ADDENDUM NO. 01

From: Craig A. Johnson, P.E.
Crist Engineers, Inc.

Date: April 28, 2023

Project: Wastewater System Improvements
Kansas Street Parallel Force Main - Phase 1 and 2
Pine Bluff, Arkansas

DETAILS I

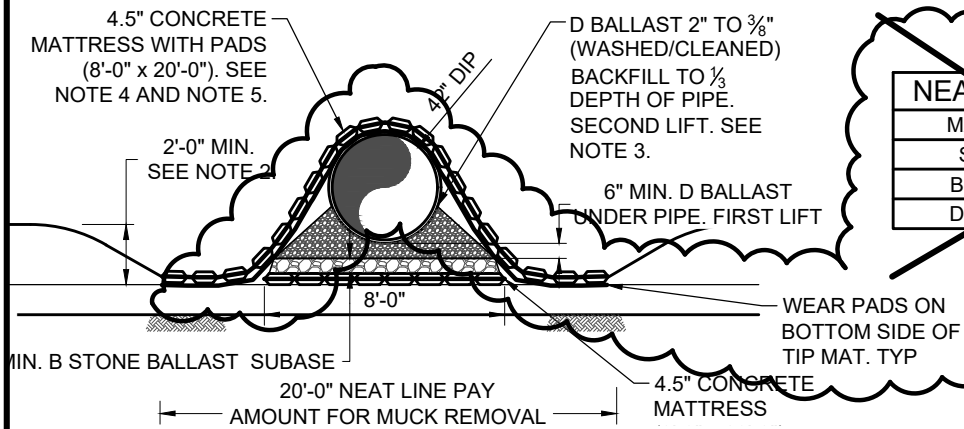
7. Drawing CZ1-01 - Details I:

A. Modify this drawing as shown on Addendum No. 1 – Details I, attached hereto.

27. C1-02 9 Appears top weight mats only go a short distance Sta. 10+50 profile conflicts, CZ1-01 Plan view indicates Top Mats required from 8+50 to 16+25, C1-02 indicates same, please clarify. **Reference lake crossing profile and station callouts on detail.**

CRIST ENGINEERS, INC.	
CONSULTING ENGINEERS		LITTLE ROCK, ARKANSAS	
PINE BLUFF, ARKANSAS			
PINE BLUFF WASTEWATER UTILITY KANSAS ST PARALLEL FORCE MAIN			
OVERALL PLAN & PROFILE			
DESIGNED: JPK	JOB NO. 2155	DATE APRIL 2023	ADD. NO. 1
DRAFTED: RDW	SCALE:	NOT TO SCALE	REF SHEET
CHECKED: CAJ			G2-03

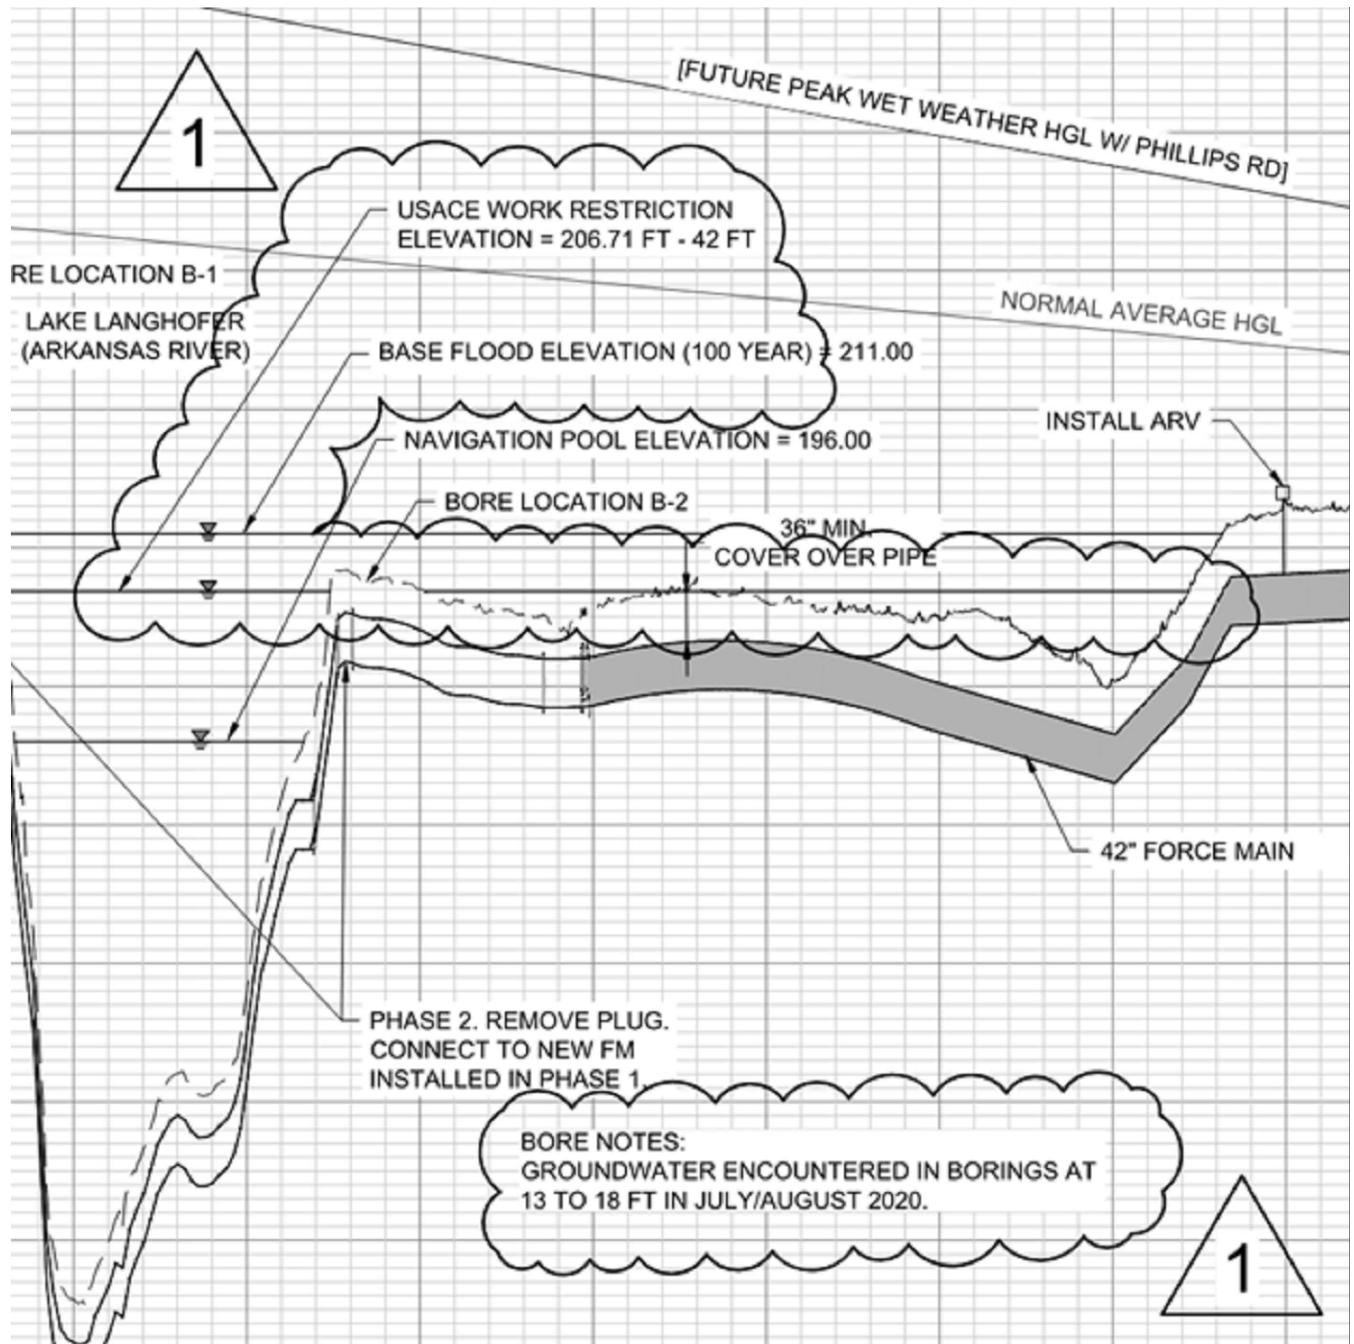
8. Drawing G2-03 – Overall Plan & Profile:

A. Modify this drawing as shown on Addendum No. 1 – Overall Plan & Profile, attached hereto.

32. In Ph 2 G2-03 it appears well points will be required near the tie-ins, does the engineer have a specified water elevation below the new pipe that ground water should maintain? **Reference Geotechnical Report provided with Bid Documents under separate cover. Also reference profile on sheet C2-02.**

CRIST ENGINEERS, INC. CONSULTING ENGINEERS LITTLE ROCK, ARKANSAS	
PINE BLUFF, ARKANSAS	
PINE BLUFF WASTEWATER UTILITY KANSAS ST PARALLEL FORCE MAIN	
VICINITY MAP - PHASE 2	
DESIGNED: JPK	JOB NO. 2155
DRAFTED: RDW	DATE APRIL 2023
CHECKED: CAJ	SCALE: NOT TO SCALE
ADD. NO. 1	
REF SHEET G2-04

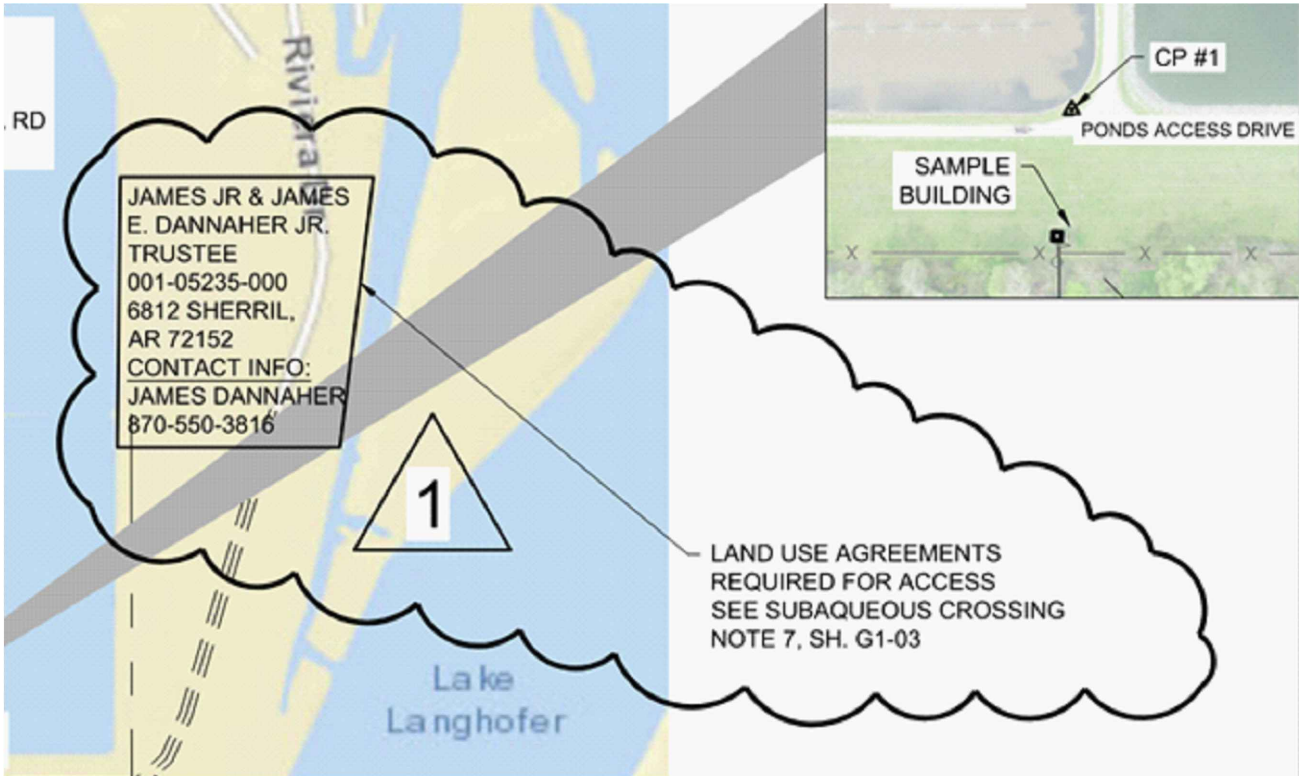
9. Drawing G2-04, Vicinity Map – Phase 2:

A. Modify this drawing as shown on Addendum No. 1 – Vicinity Map – Phase 2, attached hereto.

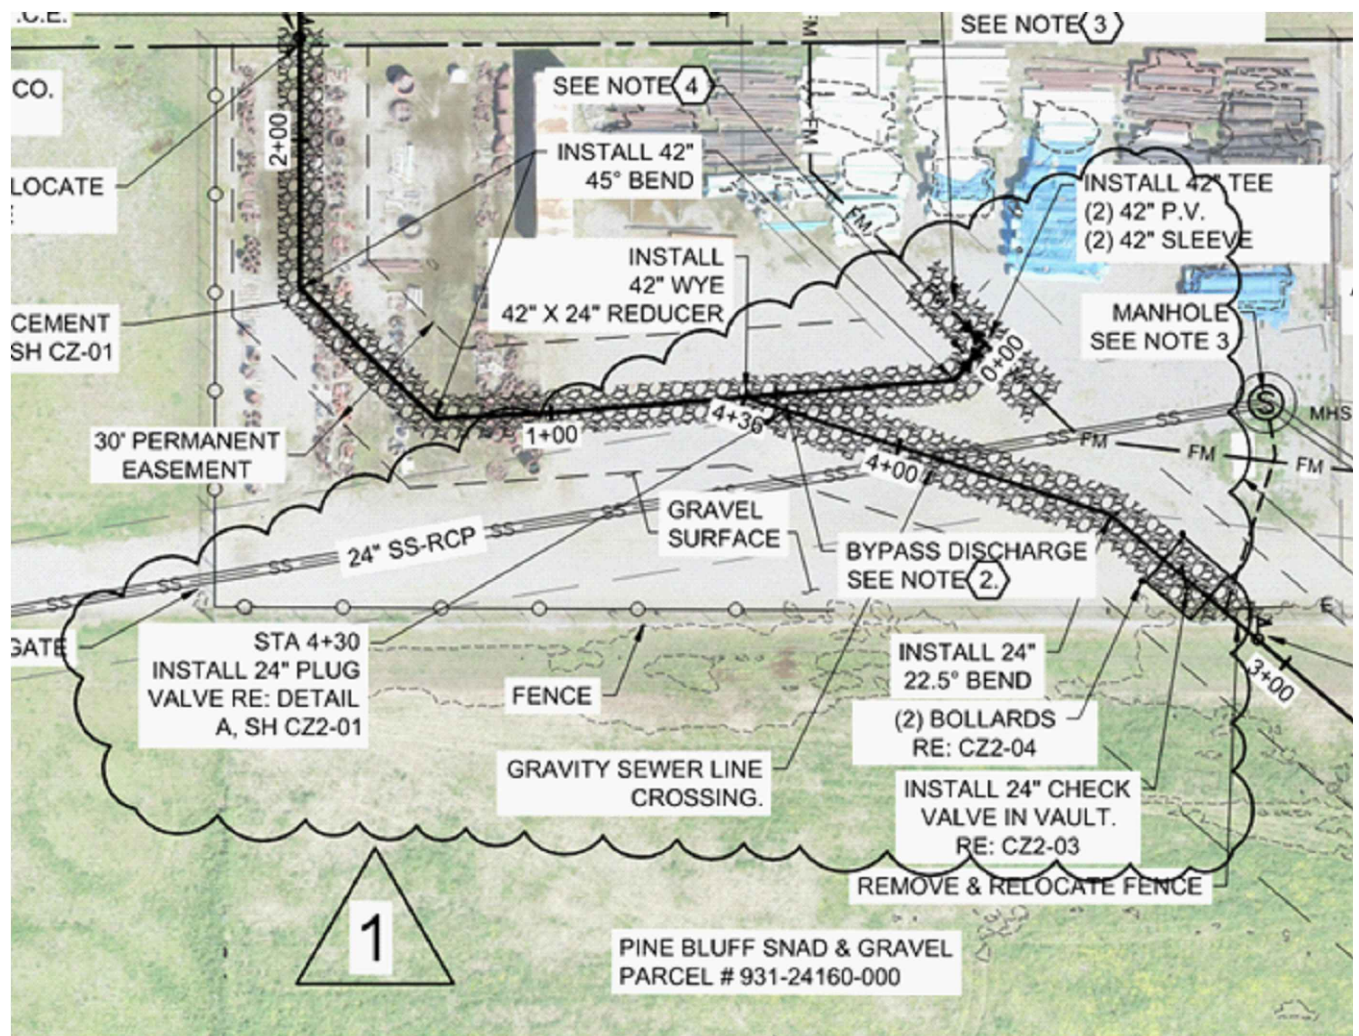
10. Drawing C2-01 – South Bank Tie-In & Proposed Yard Piping:

A. Modify this drawing as shown on Addendum No. 1 - South Bank Tie-In & Proposed Yard Piping, attached hereto.

2. STOCKPILES LOCATED WITHIN TOL LIMITS TO BE RELOCATED, IF REQUIRED, PRIOR TO CONSTRUCTION.
 3. CORE DRILL EXISTING MH AS REQUIRED TO ACCOMMODATE SUMP PUMP DISCHARGE PIPING FROM VALVE VAULT. PROVIDE LINK SEAL AROUND PIPE AND SEAL PENETRATIONS WITH NON-SHRINK GROUT.
 4. ALL MATERIAL STORED INSIDE FENCE SHALL BE RELOCATED BY OWNER. CONTRACTOR TO INDICATE LIMITS OF CONSTRUCTION BY STAKING PRIOR TO OWNER RELOCATING MATERIAL.
- 1

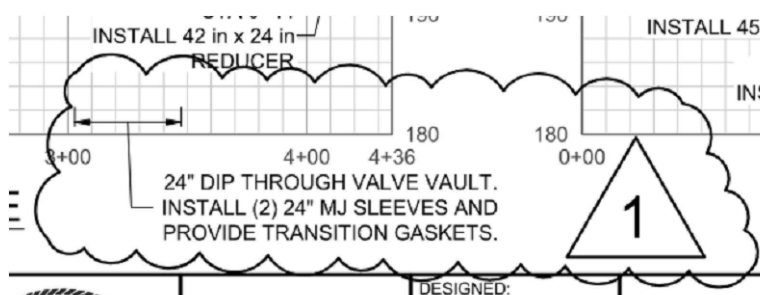
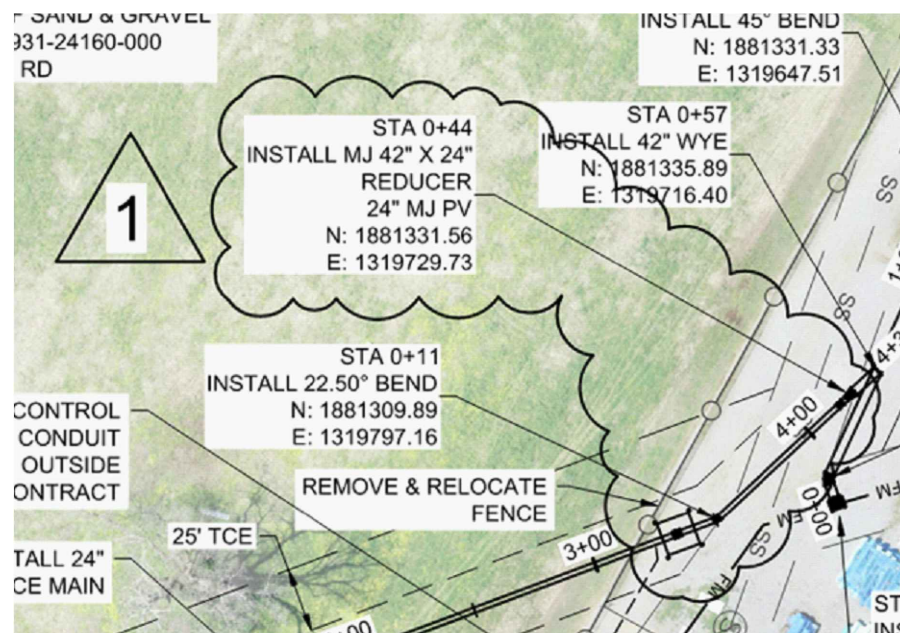
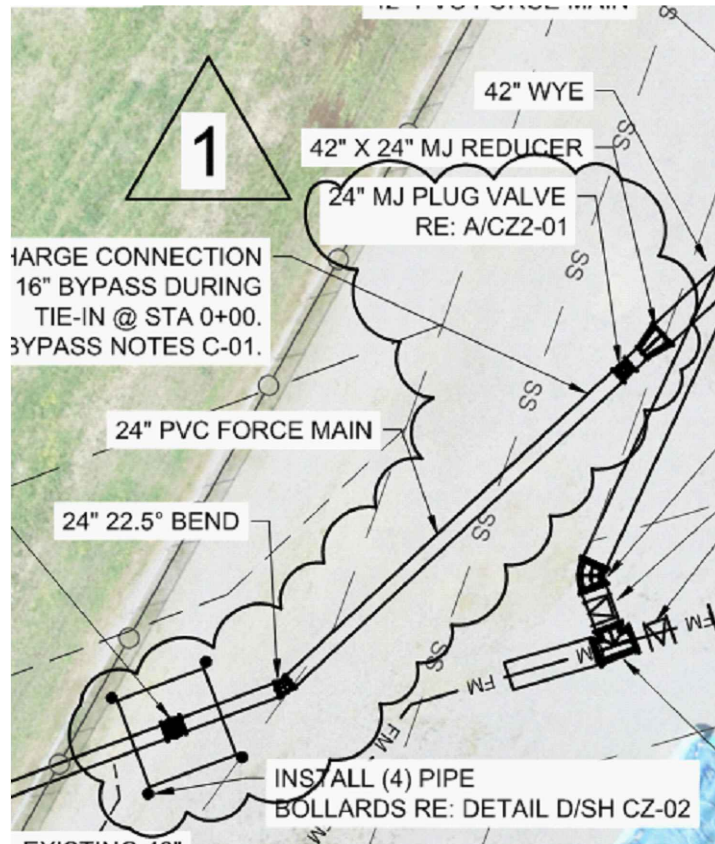
11. Drawing C2-02 – Plan & Profile 24 Inch Force Main & 0+00 – 7+00:

A. Modify this drawing as shown on Addendum No. 1 - Plan & Profile 24 Inch Force Main & 0+00 – 7+00, attached hereto.

10. Drawing Sheet No. C2-02 & 04; Bid Item 5, the bid quantity is 3 ea., but there are 4 ea. shown on the C2-02 & 04. What is the correct quantity? **See revised bid form issued via addendum no. 1 dated April 28, 2023.**

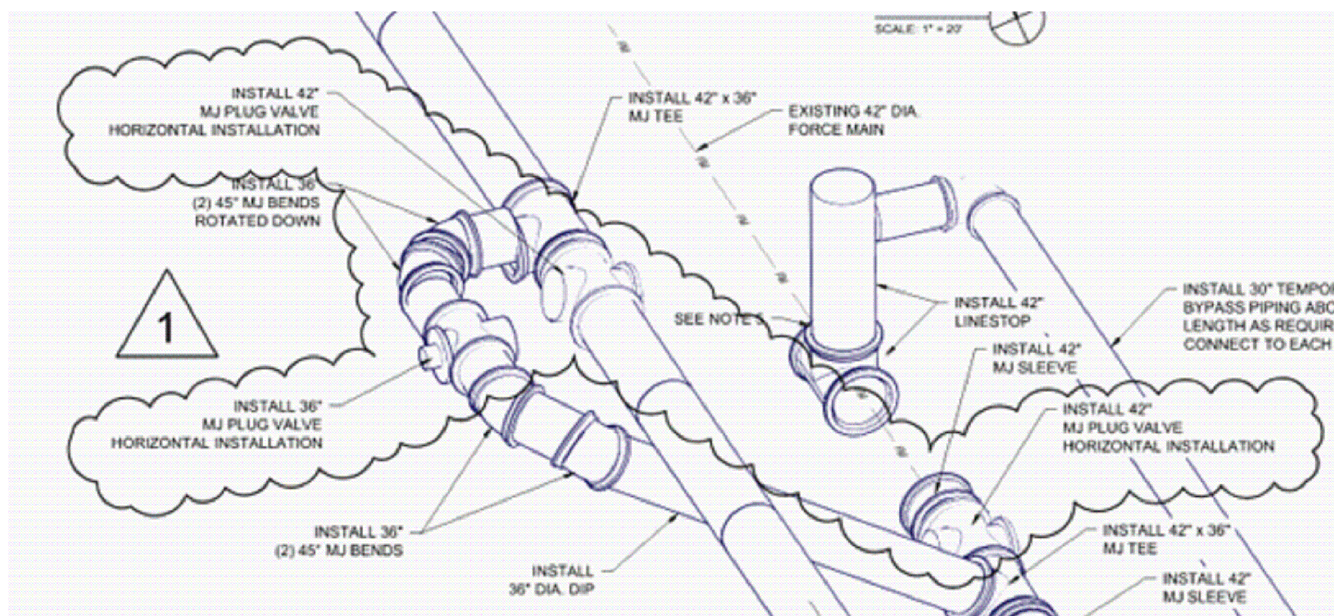
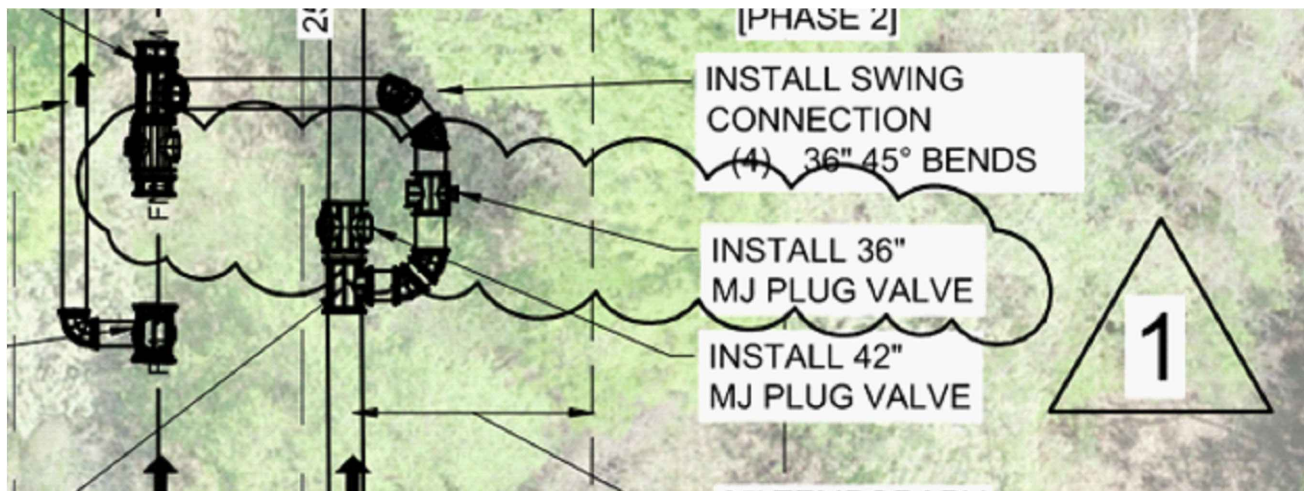
12. Drawing C2-04 – Tie-In Connection at STA 24+69:

A. Modify this drawing as shown on Addendum No. 1 – Tie-In Connection at STA 24+69, attached hereto.

11. Drawing C2-04; The Line Stop Contractors are stating that the outlet flange on the line stop valve is 24" and the bypass piping is shown as 30", will this be a problem with bypass flows? **No. Bypass piping will be 30" as shown. Contractor is responsible for providing temporary piping and fittings as required to connect to linestop discharges to facilitate bypass during tie-in. Linestop bypassing will be required to be performed during relatively dry weather.**

CHECK VALVE VAULT

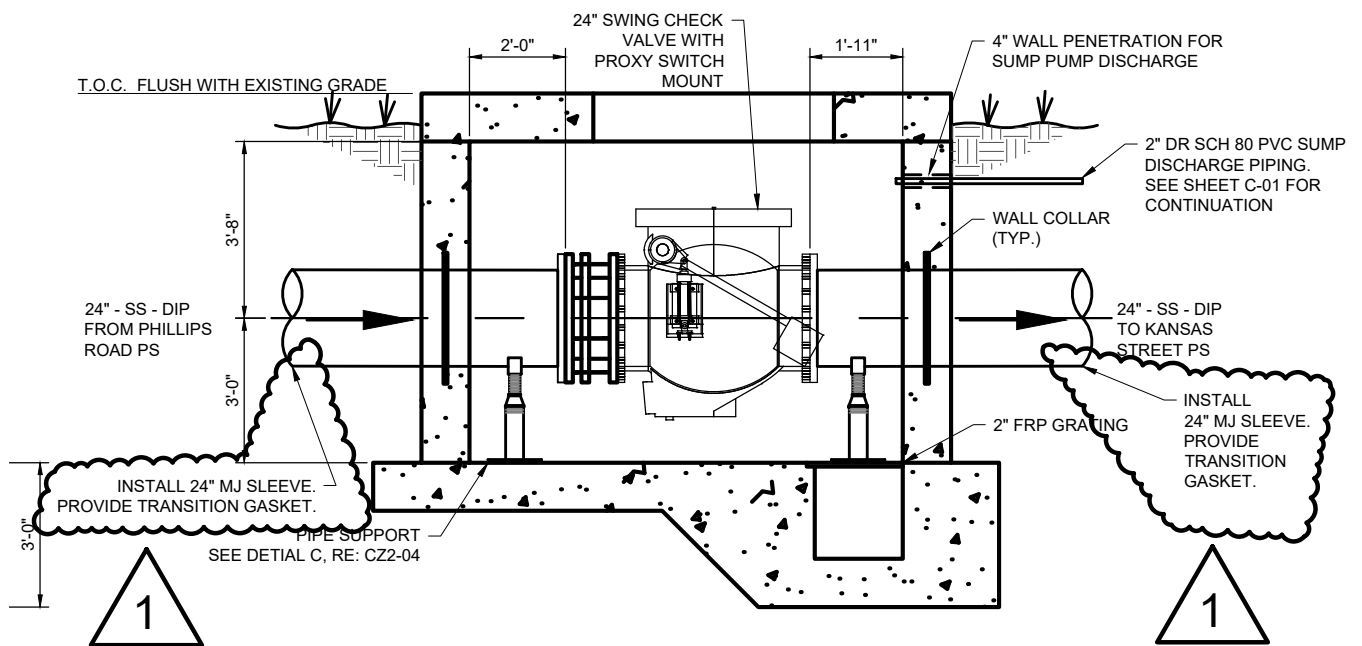
14. Drawing CZ2-03 – Details III:

A. Modify this drawing as shown on Addendum No. 1 – Details III, attached hereto.

8. Drawing Sheet No. CZ2-03; Would a precast vault be acceptable for the "Check Valve Vault", if provided as an or equal? **Yes.**
9. Drawing Sheet No. C2-04; The bid form does not have an item for 42"x36" MJ Tee's (2 ea.), should there be a bid item, or covered by Bid Item 36- Misc. & Incidentals? **See revised bid form issued via addendum no. 1 dated April 28, 2023.**

- A. Precast concrete will be allowed for the check valve vault.
